Reverse Band Strut

32710-01

Sonnax Part Summary

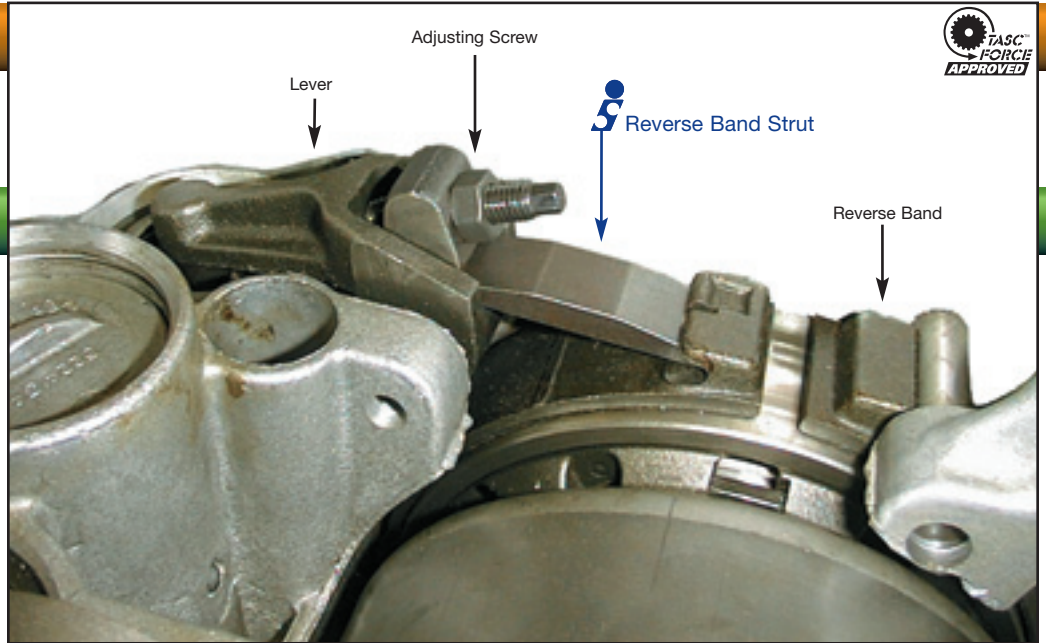
No reverse, rear band strut breakage

Thin struts cannot withstand the force of the servo piston rod as it applies the reverse band.

This Sonnax reverse band strut has a thicker cross section and is made of higher yield strength alloy steel.
